Re: Final Environmental Assessment (FEA) and Finding of No Significant Impact (FONSI) for
County of Hawai'i, Building Division, Department of Public Works
Fire Administration Support Complex
TMK (3)2-4-001:176 & 178 (previously parcel 168 [portion])
Hilo, Island of Hawai'i, Hawai'i

Final Environmental Assessment

Fire Administration Support Complex

TMK (3)2-4-001:176 & 178 (Previously Parcel 168 [portion])

Figure 3.1
Project Location Map
Environmental Assessment for the
Fire Administration Support Complex
County of Hawaii Fire Department
June 2009

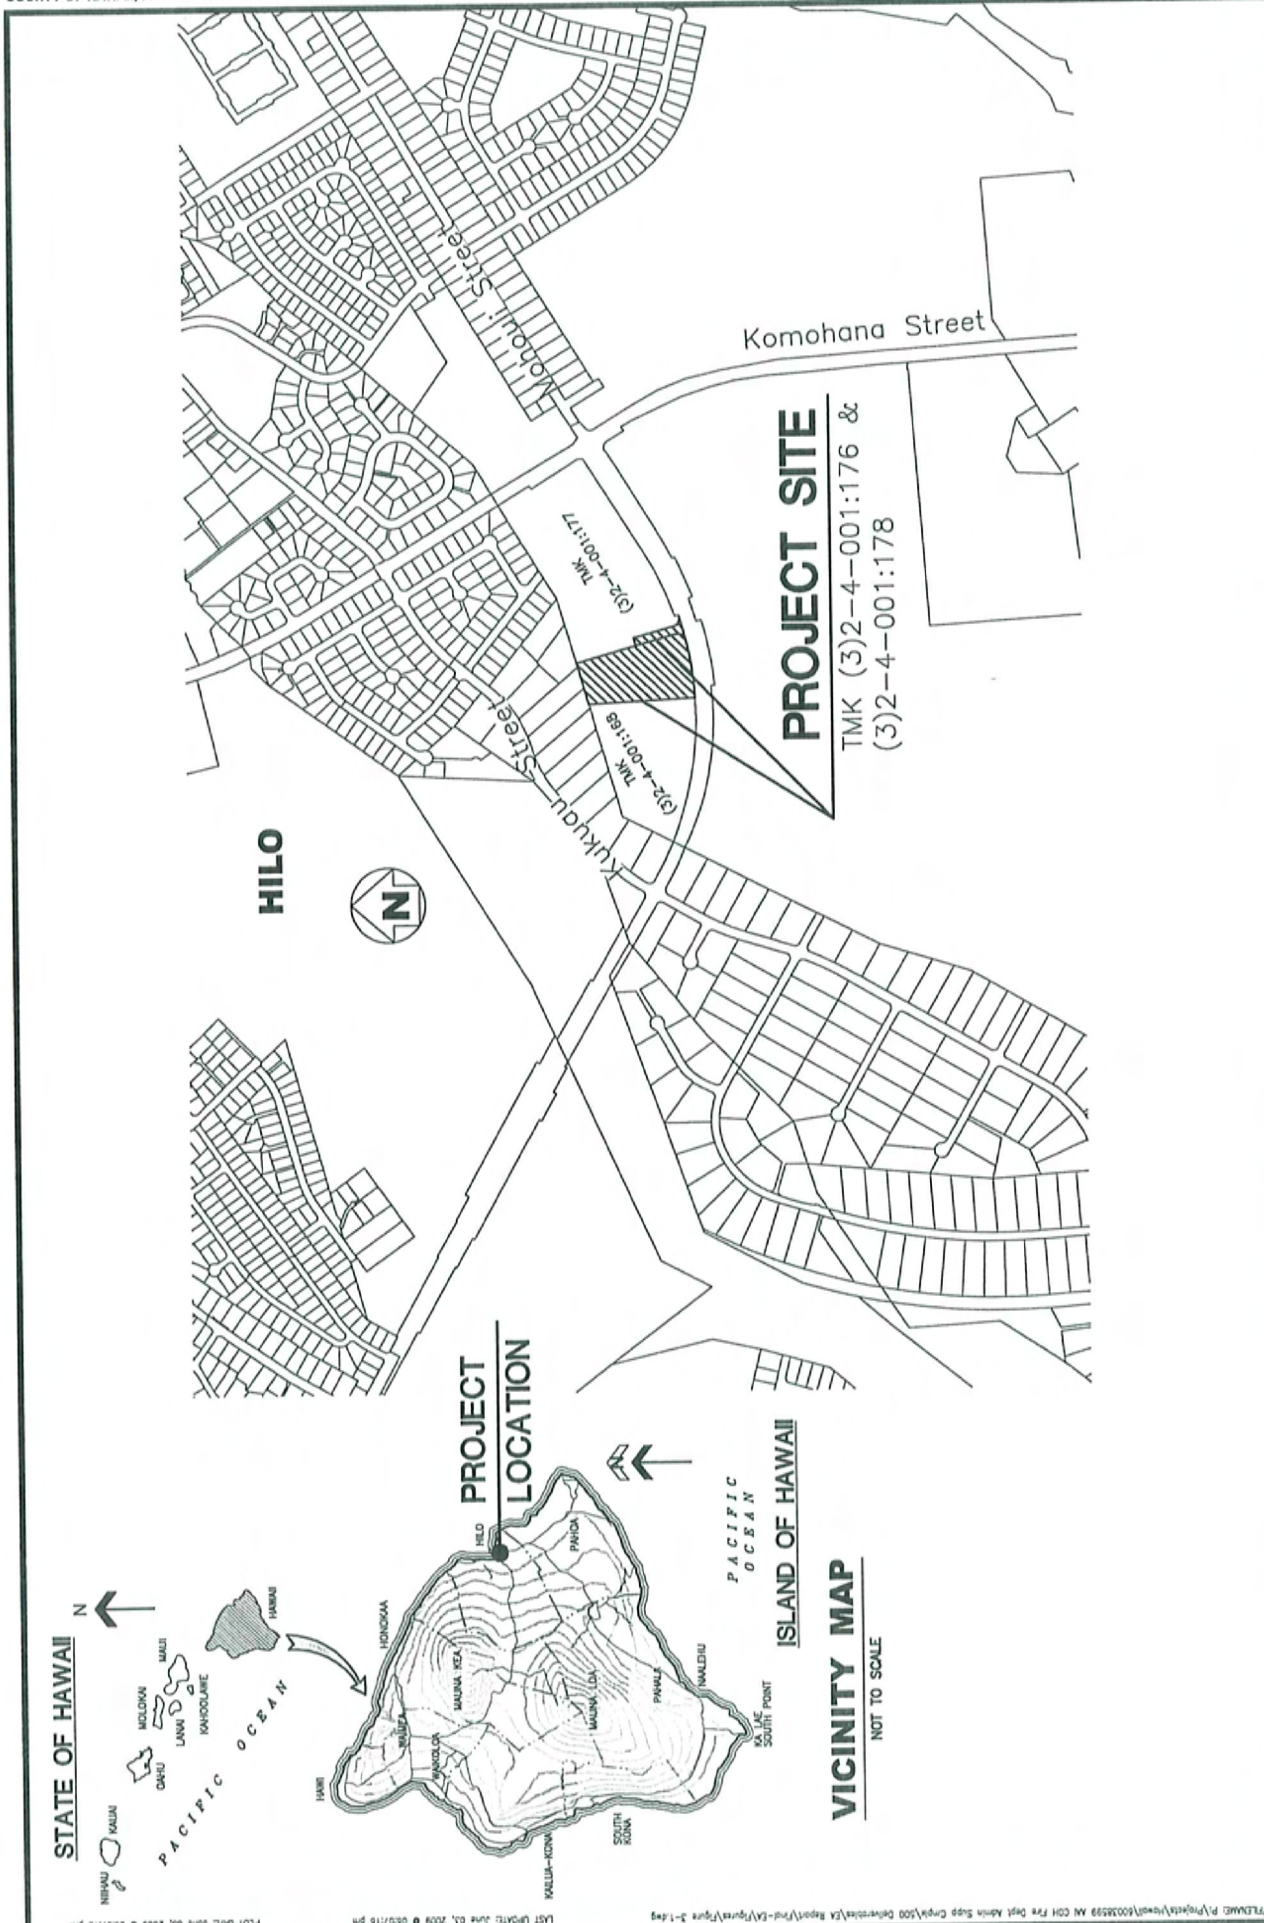
7. 3.2.2 paragraph 4, This environmental assessment will determine the impacts of the initial and future phases of the project.
8. Figure 3.1, include proposed subdivision

8. Figure 3.1, include proposed subdivision	Revision will be made to the FEA.
		9. Figure 3.2, include proposed subdivision	Revision will be made to the FEA.

Figure 3.2
EXISTING PROJECT SITE
Environmental Assessment for the
County of Hawaii Fire Department Administration Support Complex
June 2009

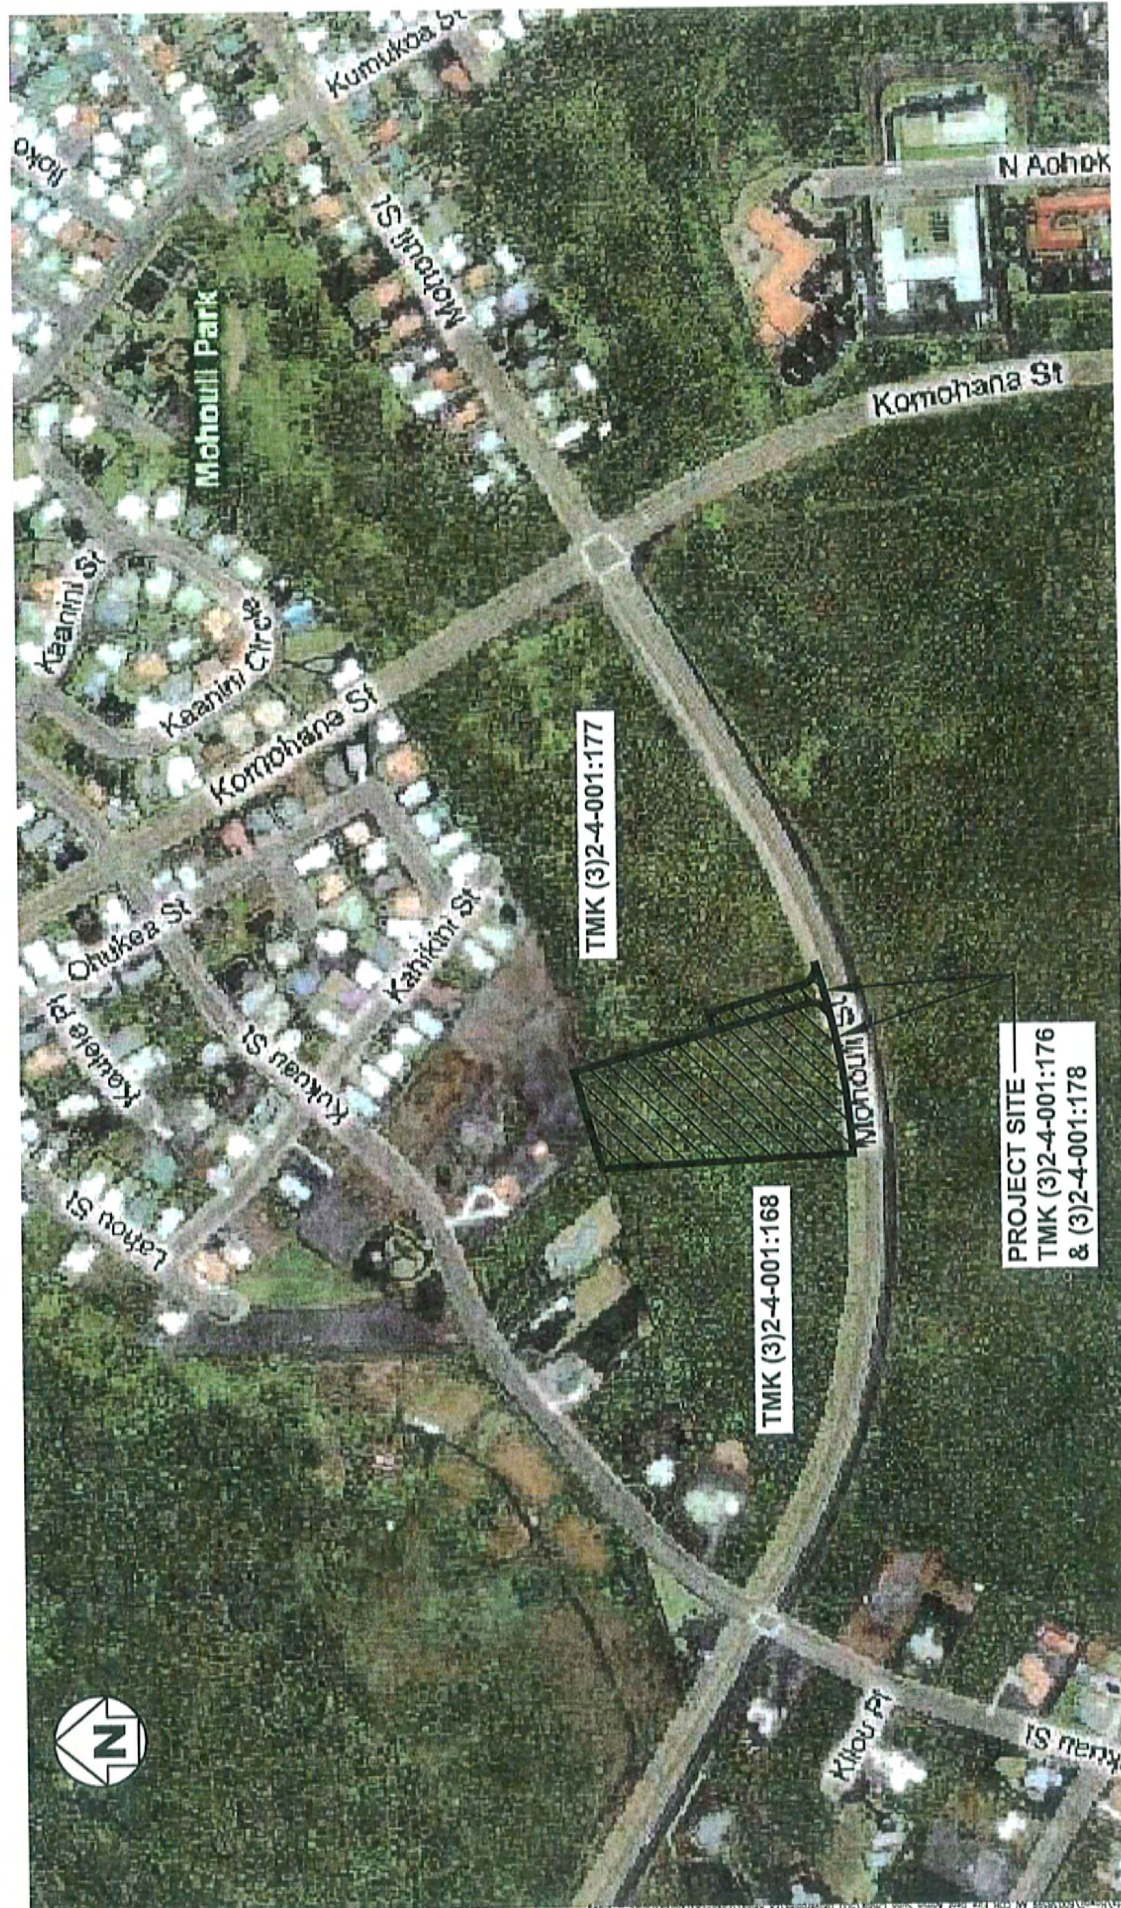
9. Figure 3.2, include proposed subdivision
10. Figure 3.3, radio tower should be located adjacent to radio room to minimize cable length. Also, proposed location highly visible and not appealing.

Figure 3.3 CONCEPTUAL SITE PLAN

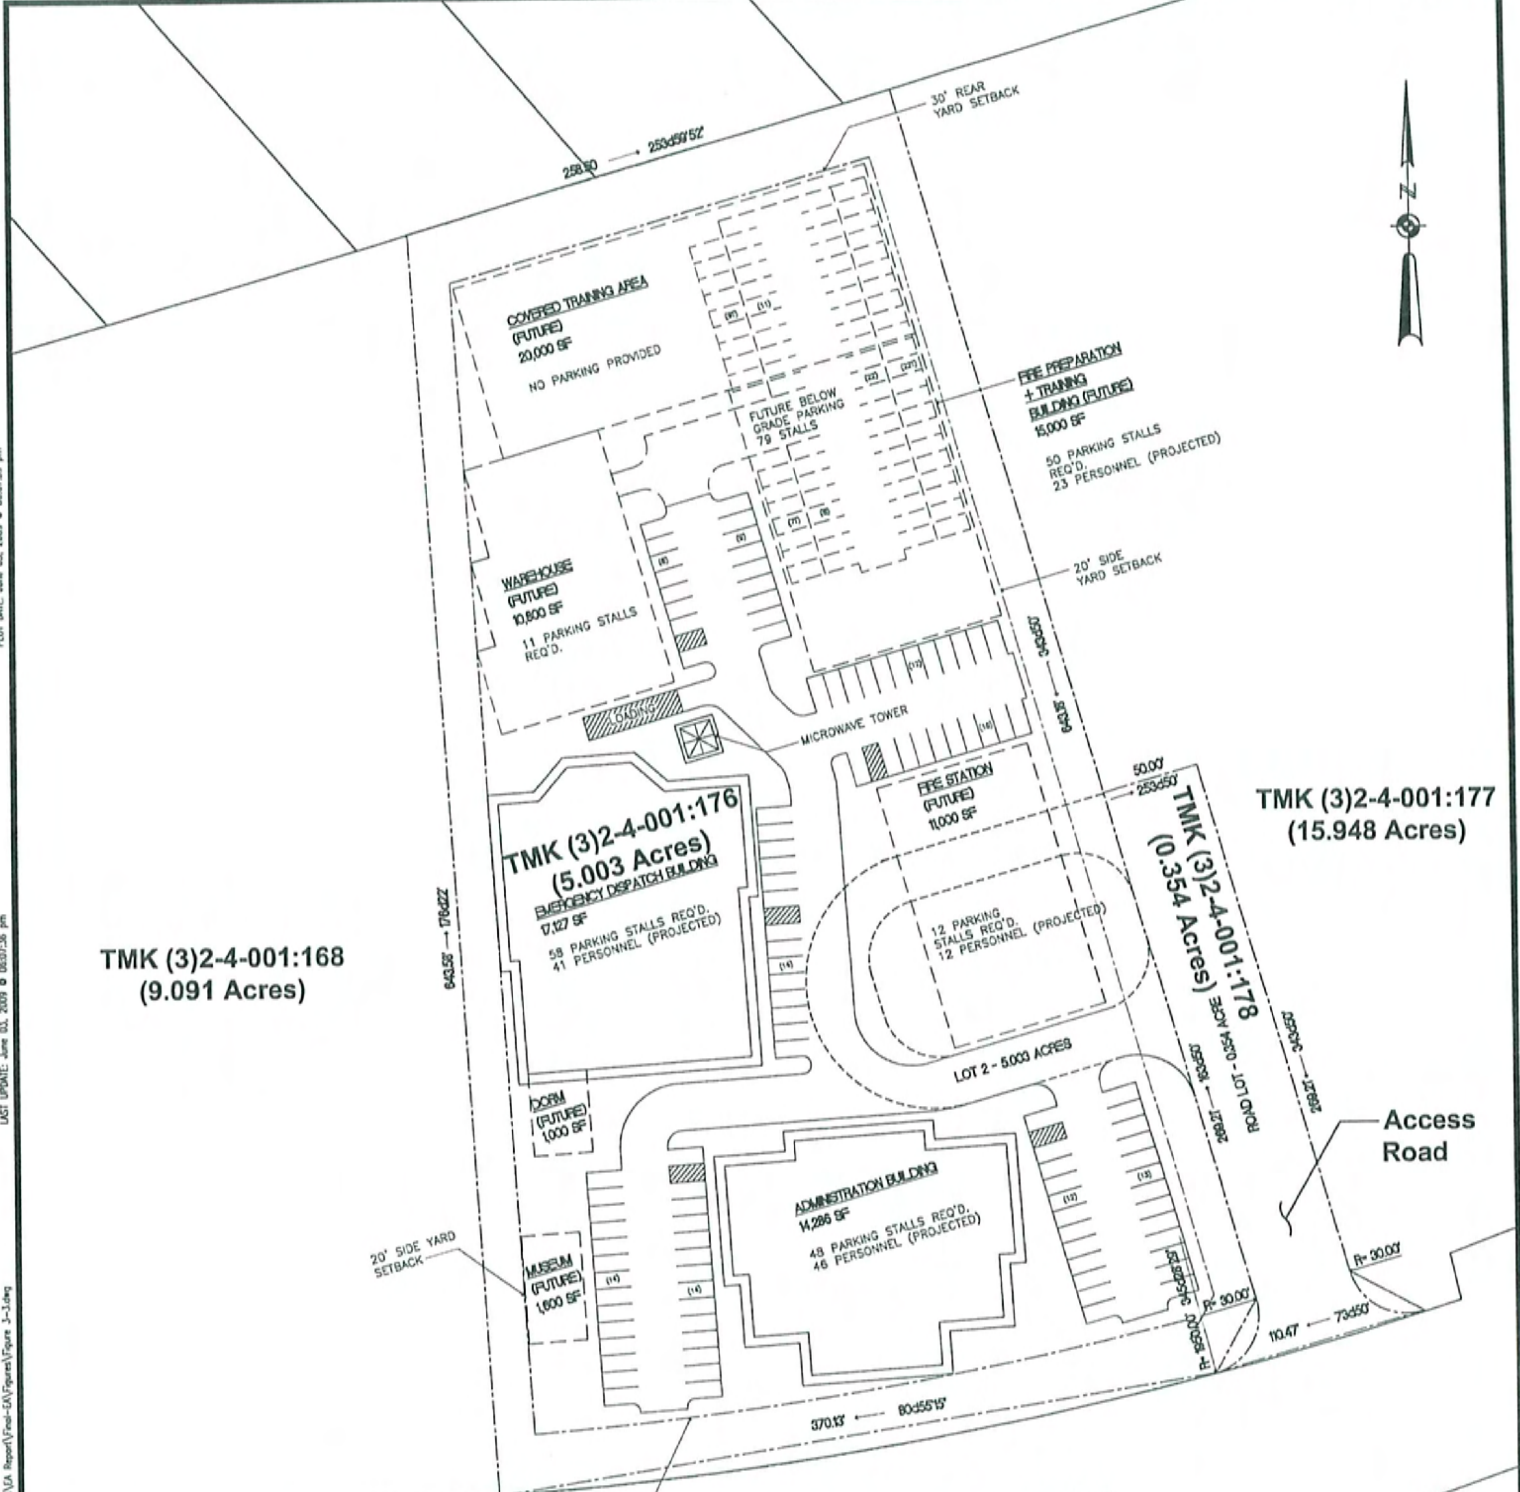
11. Figure 3.3, Fire Station location at rear of site does not necessarily support quick egress objective.
12. 3.3, budget for initial phase currently \$14,600,000

10. Figure 3.3, radio tower should be located adjacent to radio room to minimize cable length. Also, proposed location highly visible and not appealing.	Figure will be revised to reflect approved conceptual site plan (12/11/08) and revision will be made to the FEA.

11. Figure 3.3, Fire Station location at rear of site does not necessarily support quick egress objective.	Figure will be revised to reflect approved conceptual site plan (12/11/08) and revision will be made to the FEA.

**Figure 5.6
COUNTY GENERAL PLAN**

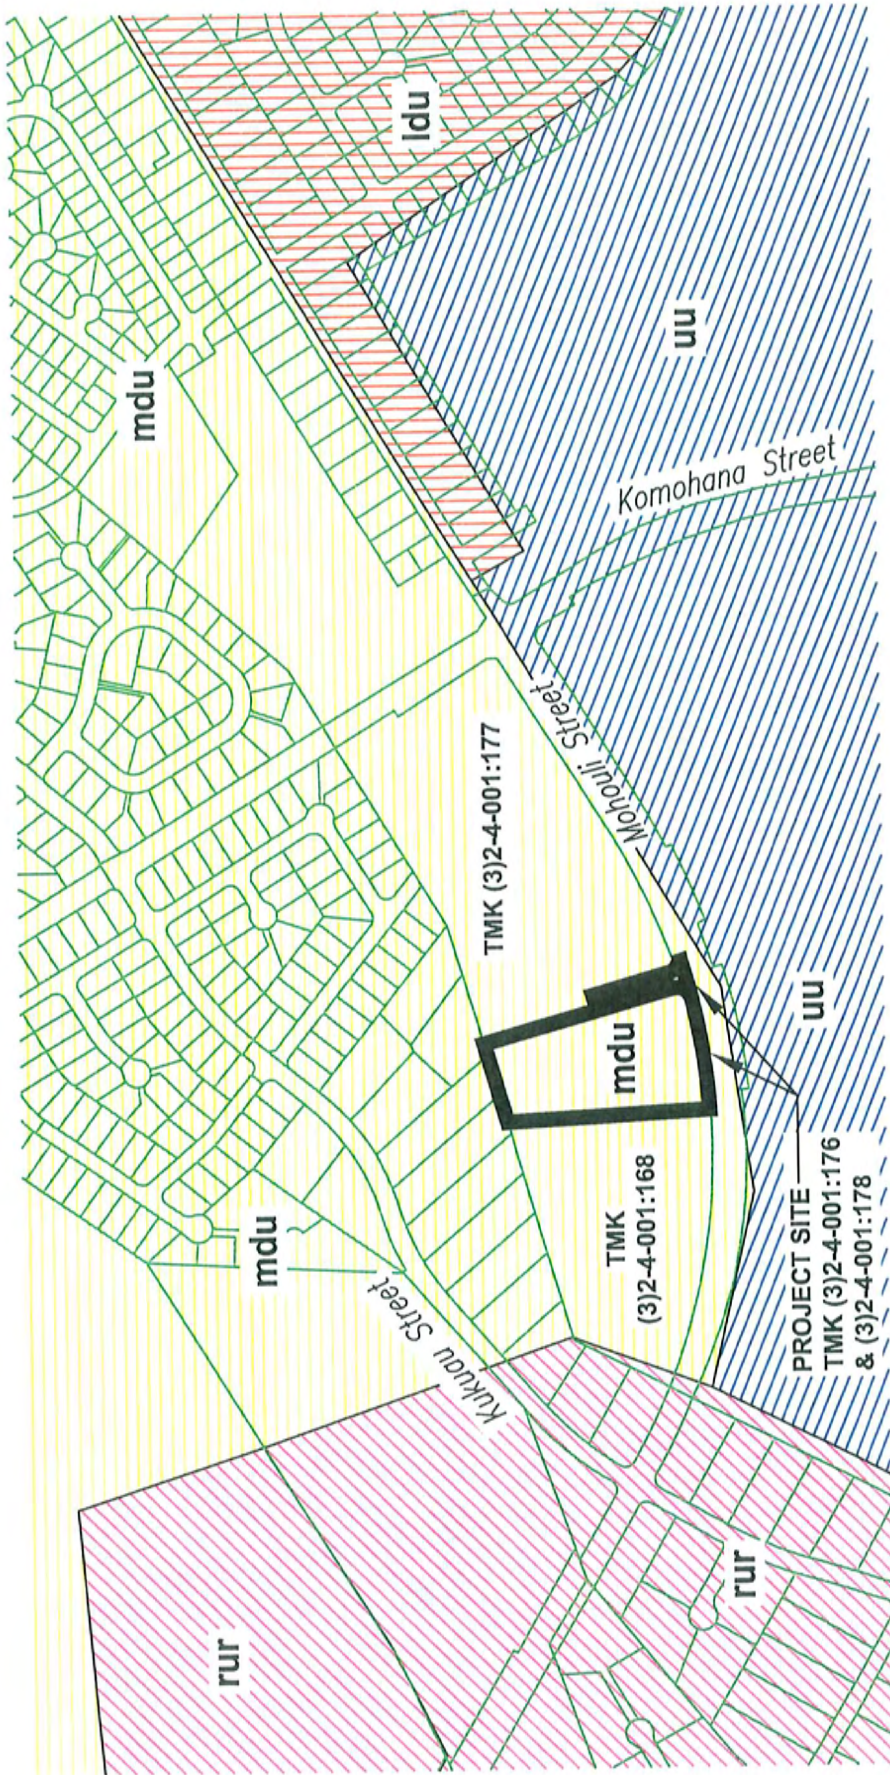
Comment 20: 20. Figure 5.6, include proposed subdivision

19. Figure 5.5, include proposed subdivision	Revision will be made to the FEA.
		20. Figure 5.6, include proposed subdivision	Revision will be made to the FEA.

Figure 5.7
COUNTY OF HAWAII ZONING
 Environmental Assessment for the
 Fire Administration Support Complex
 June 2009

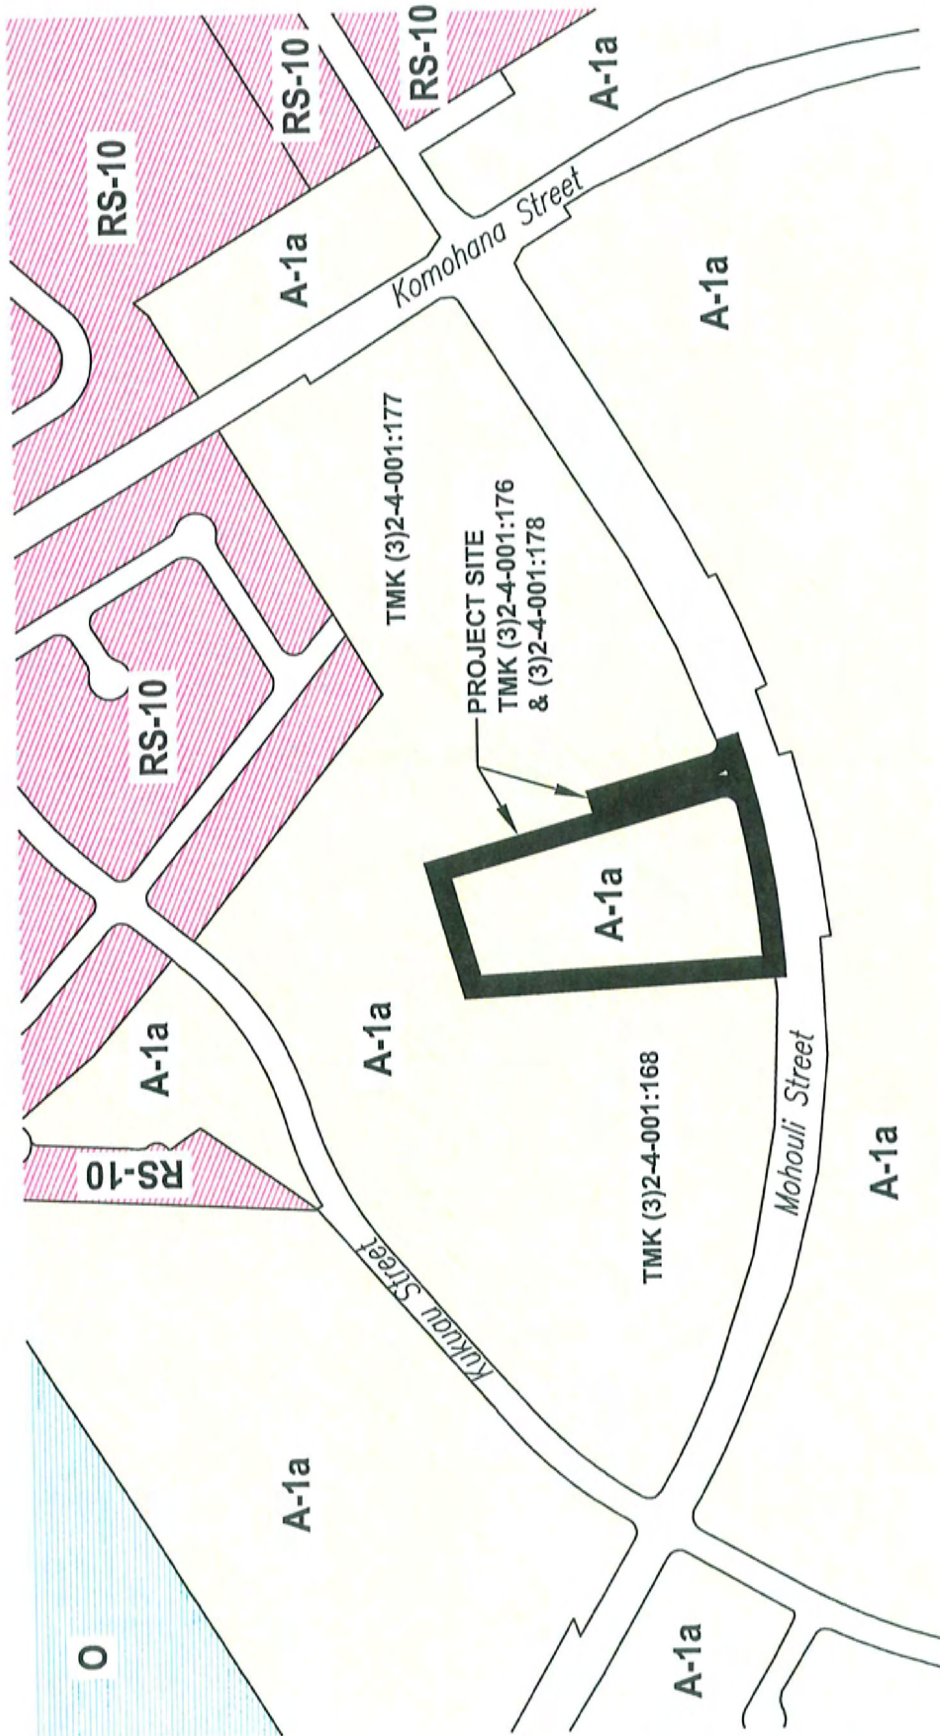
Comment 21: 21. Figure 5.7, include proposed subdivision

21. Figure 5.7, include proposed subdivision	Revision will be made to the FEA.
